TITLE **91-00-00-50Z-61**
UHF FILTER

ITS CORPORATION				REV	ECN	DATE	APV
REV	ECN	DATE	APV	THIS PRINT IS THE PROPERTY OF ITS CORP. IT SHALL NOT BE COPIED WITHOUT PERMISSION.			
				TITLE			
MATERIAL				SCH, 4 WAY SPLITTER BOARD (1227-1312)			
FINISH				DWN	SJM	2/16/94	DWG. NO.
				CHK	DWB	8-27-94	1227-3312
				REL	DWB	8-28-94	0
				SCALE ---		SHEET 1 OF 1

ITS CORPORATION			
THIS PRINT IS THE PROPERTY OF ITS CORP. IT SHALL NOT BE COPIED WITHOUT PERMISSION.			
DATE	APV	TITLE SCHEMATIC, DUAL PEAK DET BD., SINGLE SUPPLY (1227-1333)	
REV	ECN	DWN	PJK
1	7735	8/31/94	12/19/94
2	7735	12/19/94	12/19/94
3	7735	12/19/94	12/19/94
4	7735	12/19/94	12/19/94
5	7735	12/19/94	12/19/94
6	7735	12/19/94	12/19/94
7	7735	12/19/94	12/19/94
8	7735	12/19/94	12/19/94
9	7735	12/19/94	12/19/94
10	7735	12/19/94	12/19/94
11	7735	12/19/94	12/19/94
12	7735	12/19/94	12/19/94
13	7735	12/19/94	12/19/94
14	7735	12/19/94	12/19/94
15	7735	12/19/94	12/19/94
16	7735	12/19/94	12/19/94
17	7735	12/19/94	12/19/94
18	7735	12/19/94	12/19/94
19	7735	12/19/94	12/19/94
20	7735	12/19/94	12/19/94
21	7735	12/19/94	12/19/94
22	7735	12/19/94	12/19/94
23	7735	12/19/94	12/19/94
24	7735	12/19/94	12/19/94
25	7735	12/19/94	12/19/94
26	7735

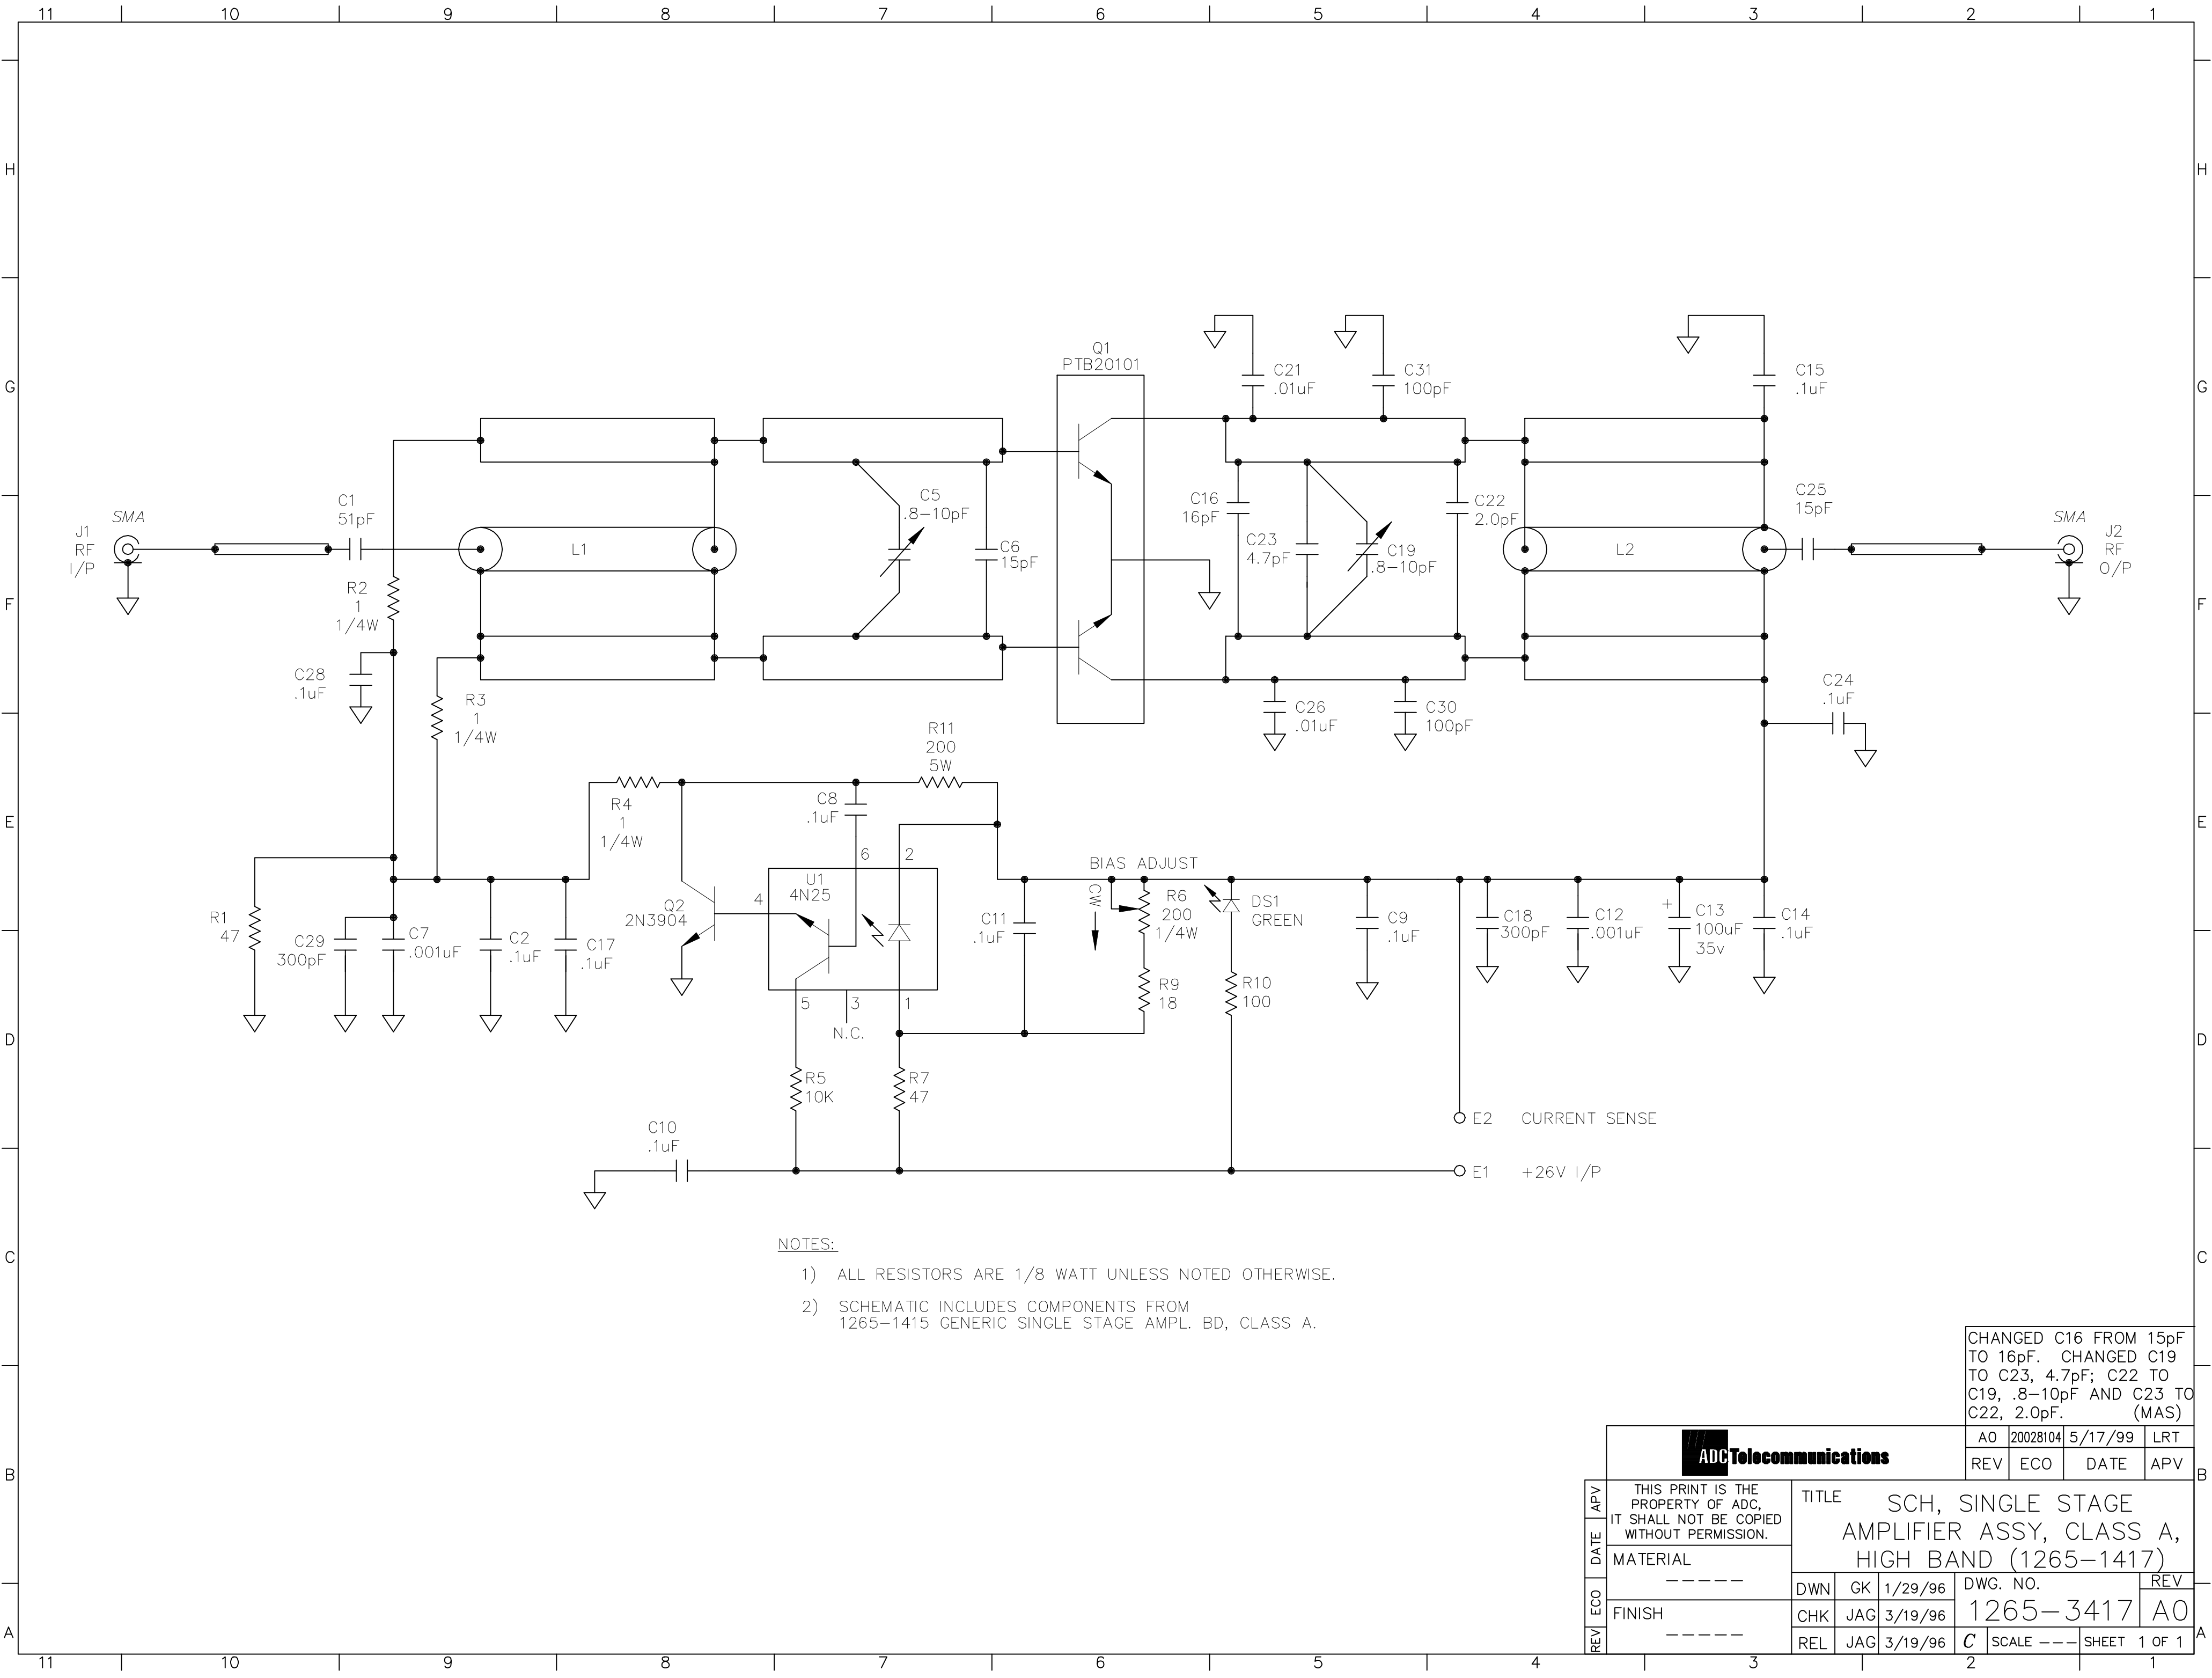
CHANGED C16 FROM 15pF TO 16pF. CHANGED C19 TO C23, 4.7pF; C22 TO C19, .8-10pF AND C23 TO C22, 2.0pF. (MAS)

ADC Telecommunications		A0	20028104	5/17/99	LRT
		REV	ECO	DATE	APV
APV	TITLE SCH, SINGLE STAG AMPLIFIER ASSY, CLASS A, LOW BAND (1265-1418)				
DATE					
REV	MATERIAL		DWN	GK	1/29/96
ECO	FINISH		CHK	JAG	3/19/96
REV	---		REL	JAG	3/20/96
		DWG. NO.		REV	
		1265-3418		A0	
		SCALE ---		SHEET 1 OF 1

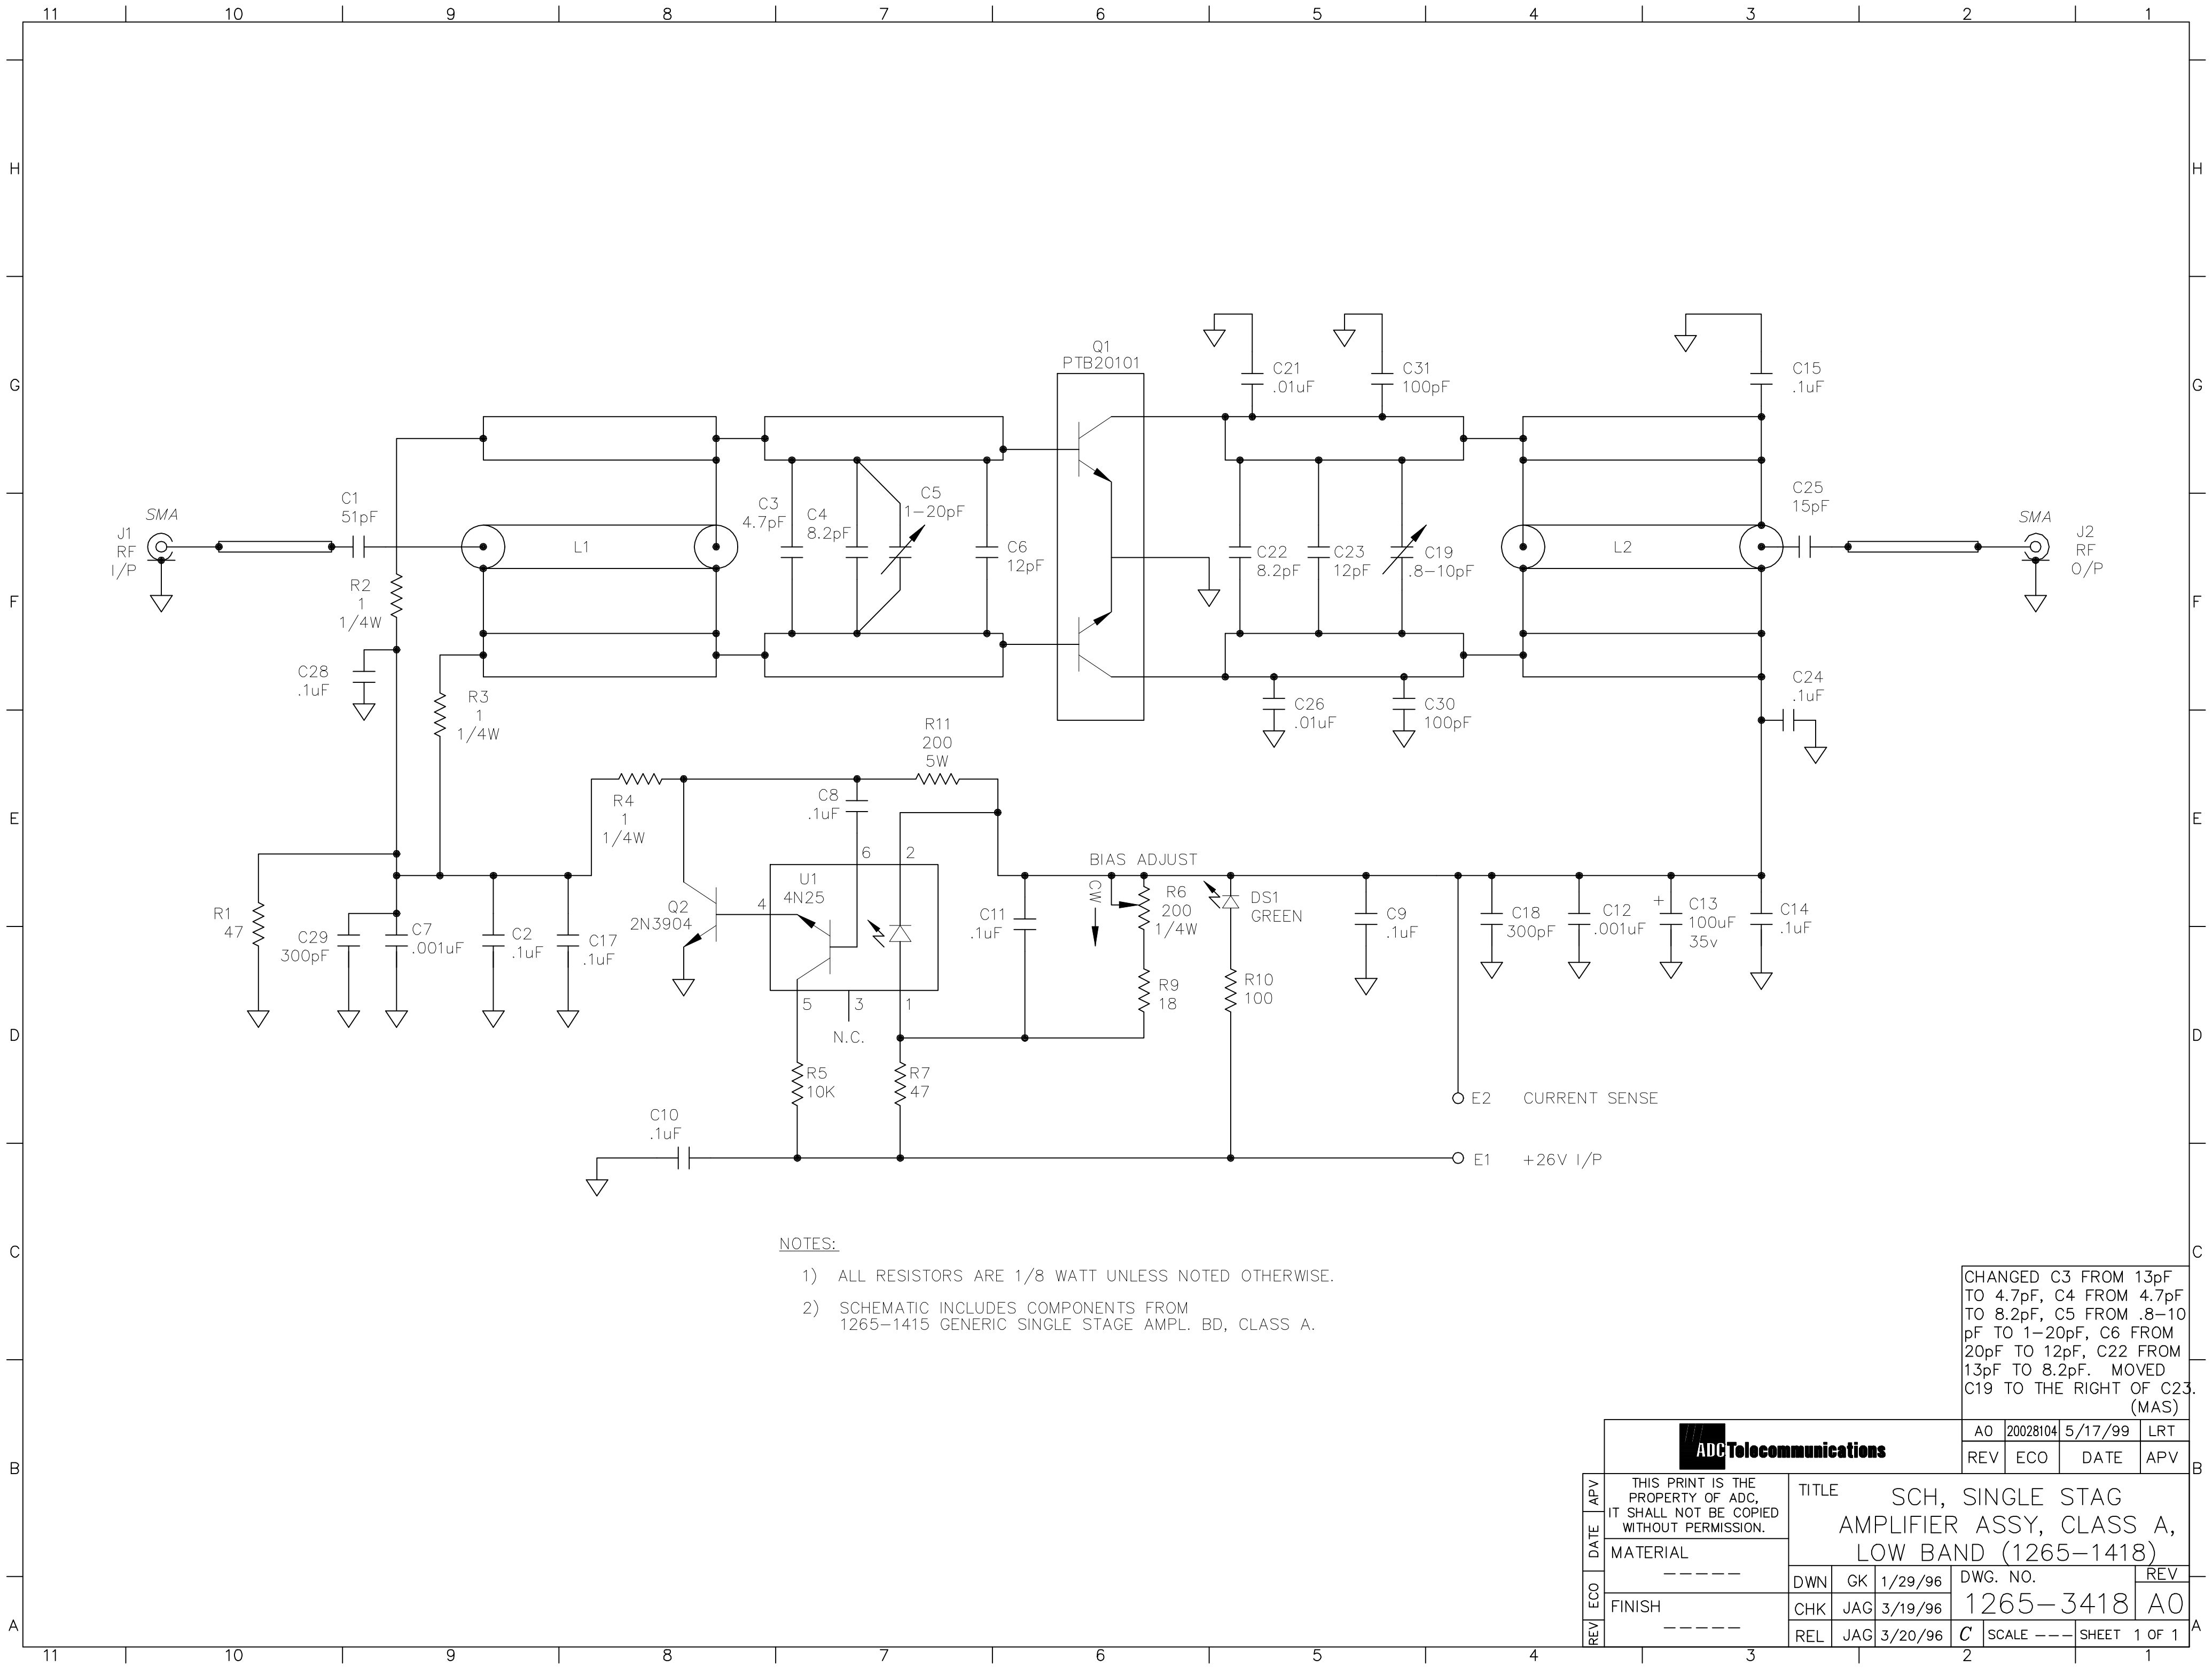
CHANGED C3 FROM 13pF TO 4.7pF, C4 FROM 4.7pF TO 8.2pF, C5 FROM .8-10 pF TO 1-20pF, C6 FROM 20pF TO 12pF, C22 FROM 13pF TO 8.2pF. MOVED C19 TO THE RIGHT OF C23. (MAS)
